NOvA Operations Review Response to Questions

**Fermilab Neutrino Division Technical
Support Department**

IFIX control system graphic of air dehumidifier system, showing redundancies.

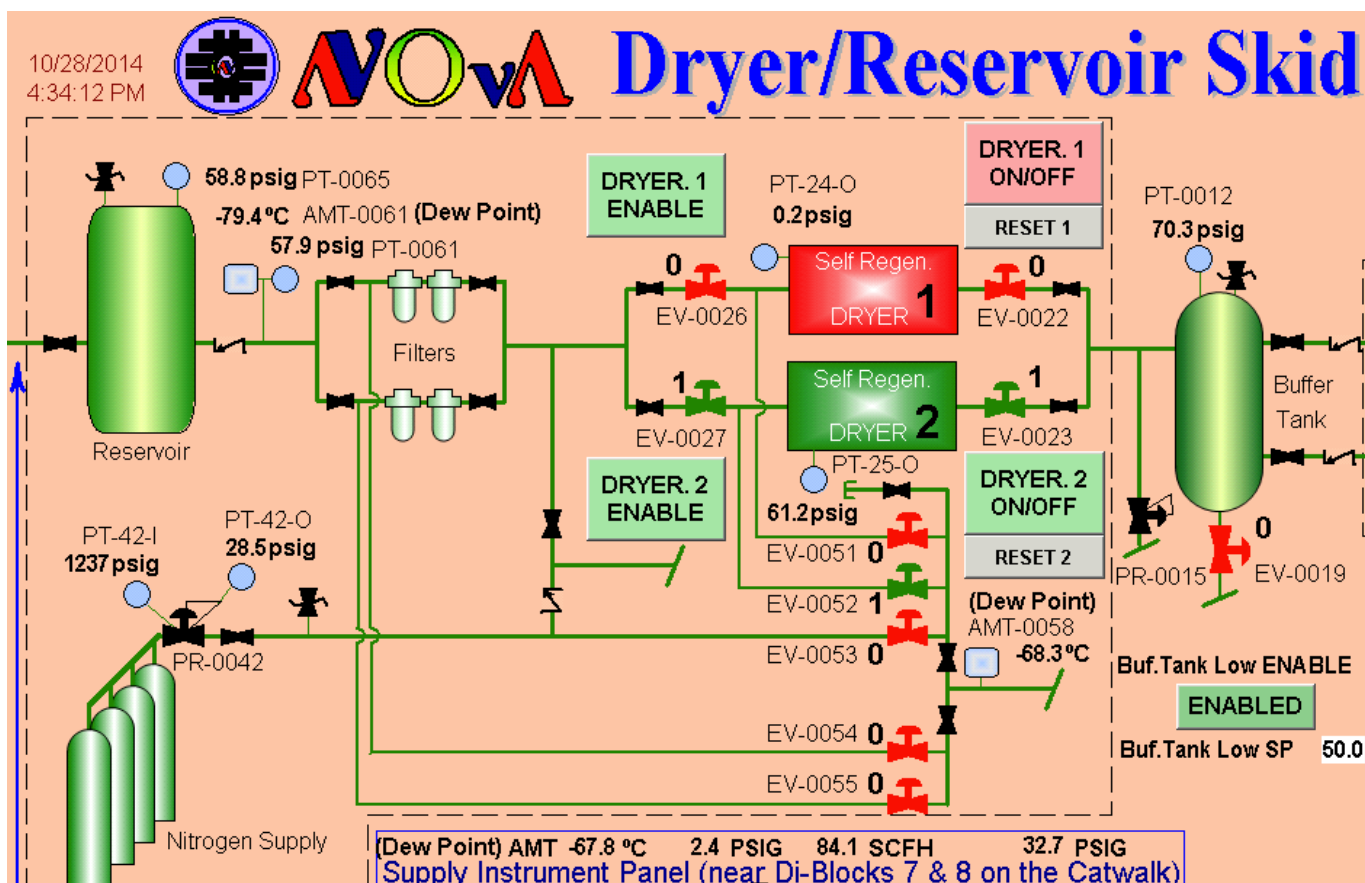
- Other components and systems can cause downtime for the NOvA detectors
- Mechanical systems:
- Water cooling system
 - Mitigation – redundancy
 - System interlocked on reservoir level
- Dry air cooling system
 - Mitigation – redundancy
 - System interlocked on dew point of cooling air.

Failure Modes (7)

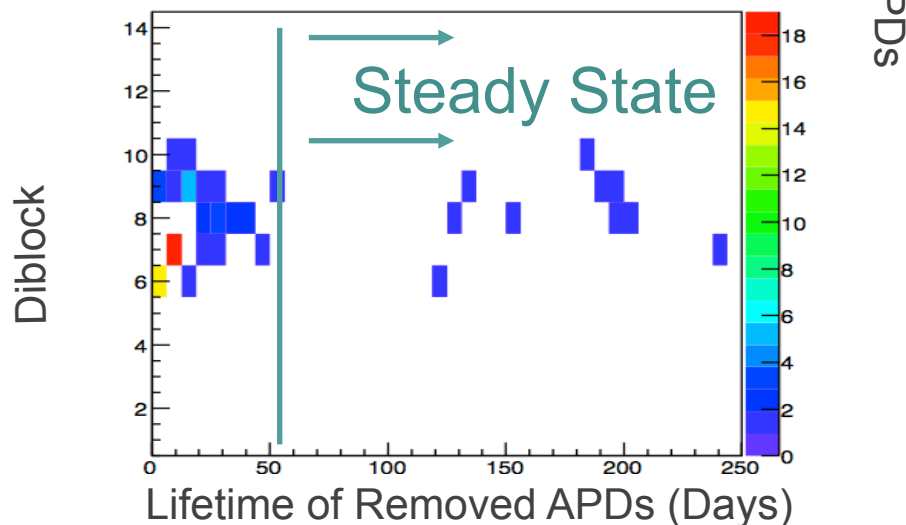
- > Have you performed a Failure Mode Analysis? Can you provide a list of failures that would significantly affect detector performance? Please comment on whether or not the resources required to address such failures in a timely manner have been identified (e.g. parts, people with requisite skill set).

Rates not yet finalized, but seem consistent with 10 years of operations, possibly with some additional APD's (few hundred) either new or from removed stock of earlier type.

Similar analysis ongoing for FEB and TECC, which have significant spares.
